GEOCRES No. 30M5-62DIST. 4 REGION                     W.P. No. 170-67-01  
(former 195-58-00)CONT. No. 76-128W. O. No.                     STR. SITE No. 10-194HWY. No. 403LOCATION Waterdown Rd.  
Retaining WallNo. of PAGES -

W.P. 170-67-01, Site No. 10-194  
Proposed Retaining Wall  
Waterdown Road Underpass  
Highway 403, District No. 4

**Re: W.P. 170-67-01, Proposed Interchange at**  
**Highway 403/Waterdown Road, Bridge #12,**  
**Original W.P. 195-58-01,**  
**Proposed Retaining Wall.**

W.P. 170-67-01 Interchange at  
C.A.H. 403 and Waterdown Road  
Br. #12 - original W.P. 195-58-01  
Proposed Retaining Wall

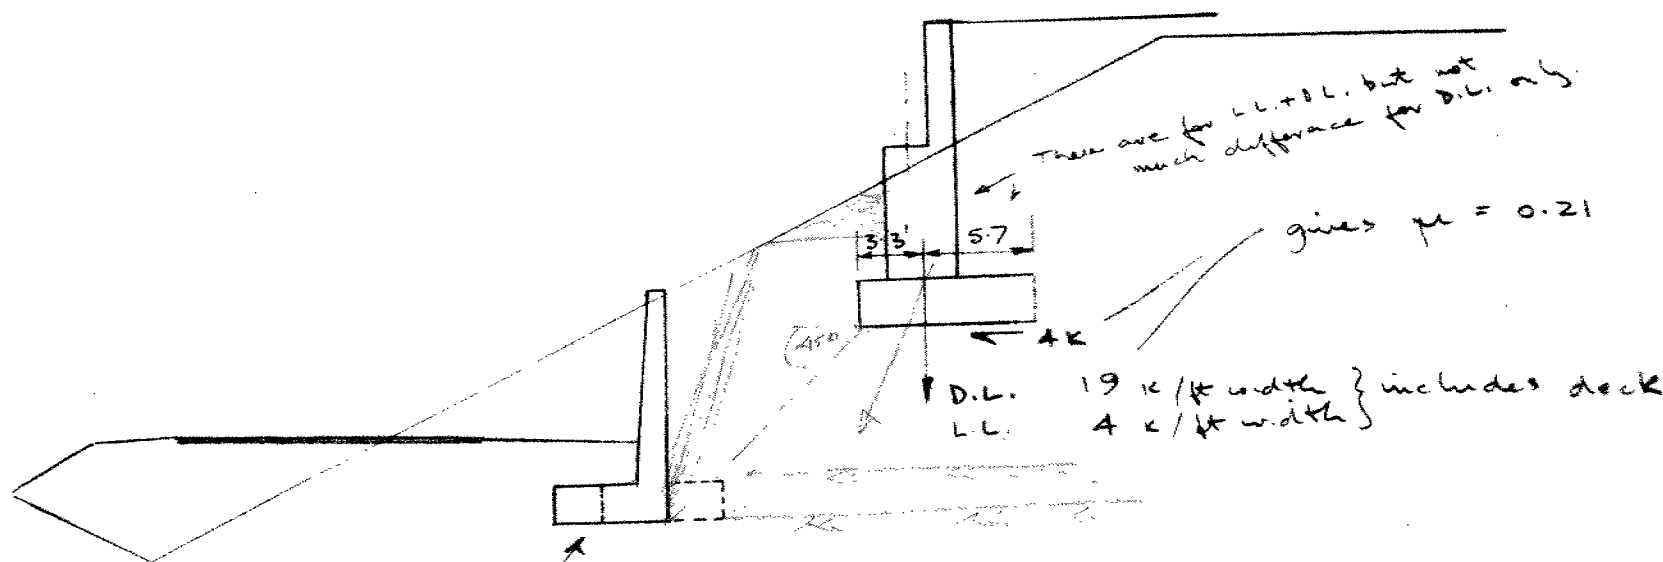
As suggested in the above memo, would you please check the factor of safety of the abutment against sliding and also confirm that the proposed location of the retaining wall is quite in order at your earliest convenience?

I am also enclosing a copy of the sketch showing the proposed location of the retaining wall with relation to the abutment.

Retaining wall this slope would slide  
Assume dotted shape

Passive pressure of soil in front of abutments is not considered. In this case the friction on the base is well below the permissible value.

The scheme is obviously feasible. I assume that the doubt in your mind is whether shoring will be required. It seems to be a rather early stage to consider such details, but I have sent to K. Selby the data he needs to investigate this.

Figures shown are approximate and  
unchecked but should be good enough for your purposes.  
If accuracy is important we can get exact figures later  
during design stage.

SKETCH SHOWING PROP. RETAINING WALL IN  
NORTH-END SPAN OF THE FREEWAY  
UNDERPASS AT WATERDOWN RD.

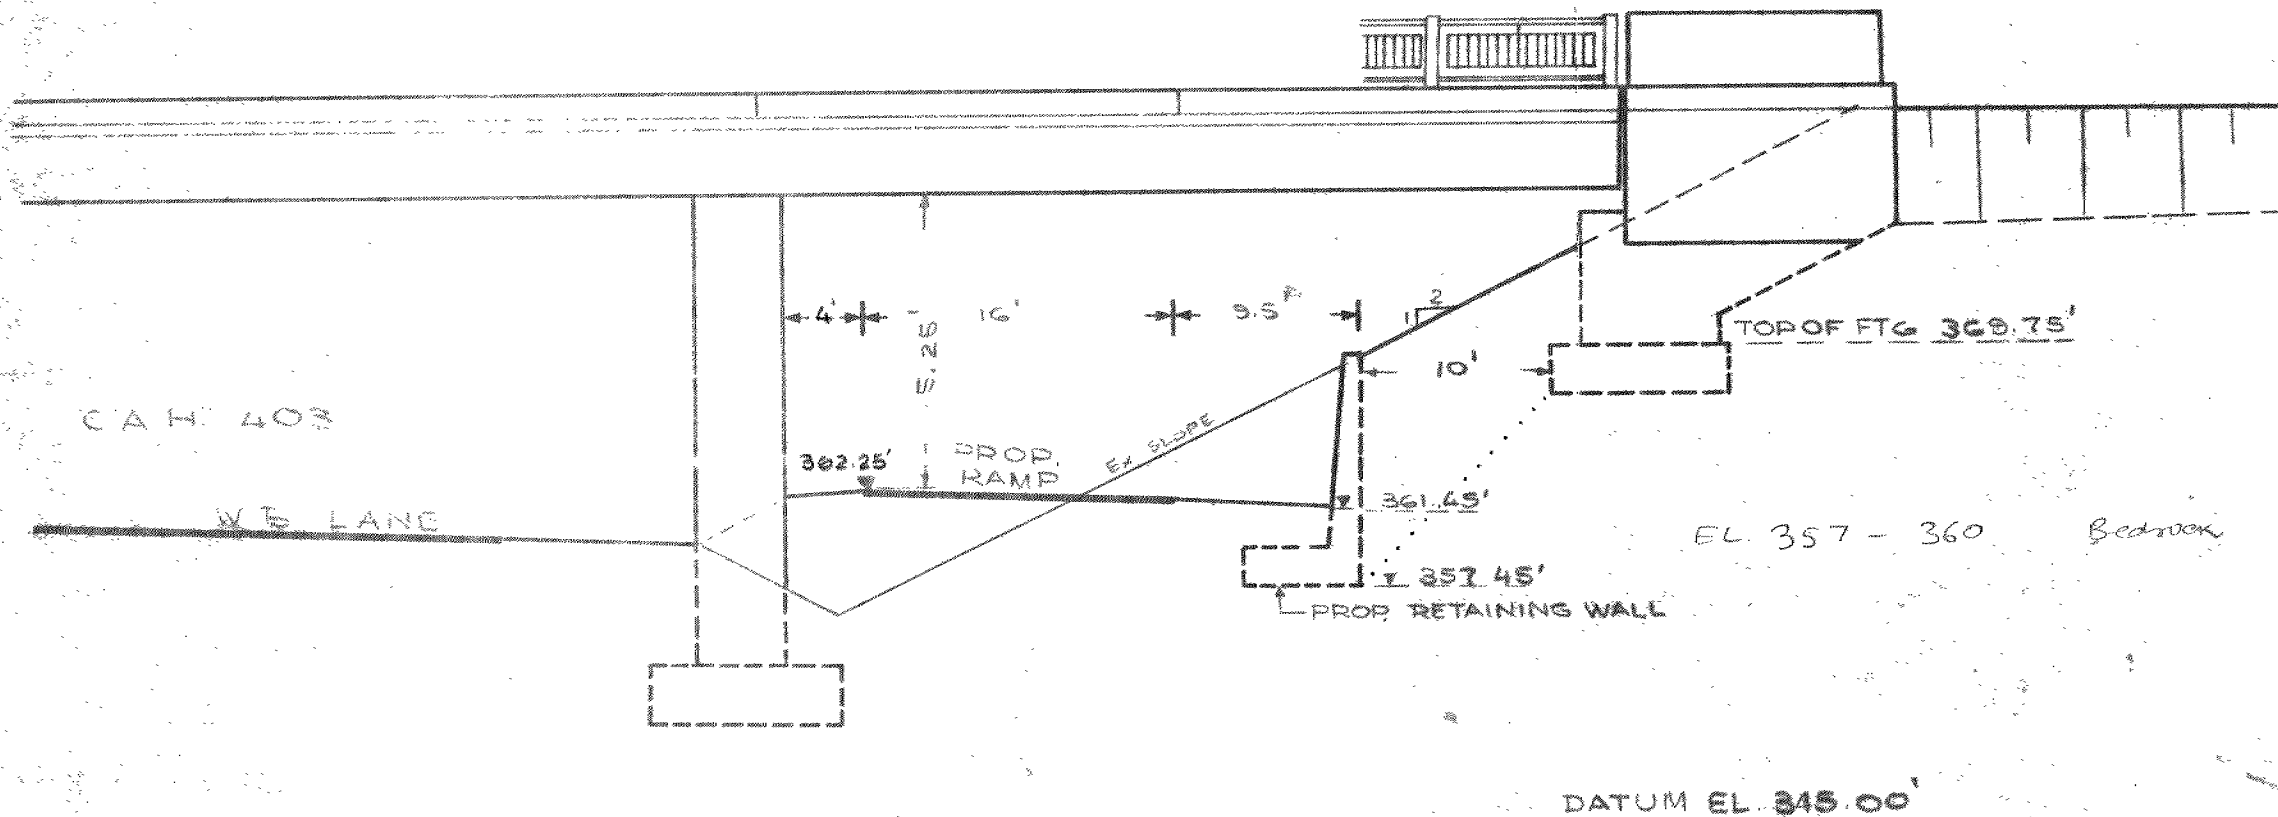
As a result of the above discussion, I am now enclosing a sketch showing the elevation of the end span of the above bridge and also my proposed location of the retaining wall.

Would you kindly investigate the feasibility of this proposal and let me have your comments at your earliest convenience?

As requested, we have reviewed your proposal for the abovementioned retaining wall as shown on the sketch attached to your memo dated December 14, 1970. We are of the opinion that the wall can be constructed without detrimental effect on the existing abutment, provided that removal of soil in front of the abutment footing will not drastically reduce the safety factor of the abutment against sliding. Normally passive resistance is neglected in the design, but it would be as well to check with the Bridge Office whether this is actually the case.
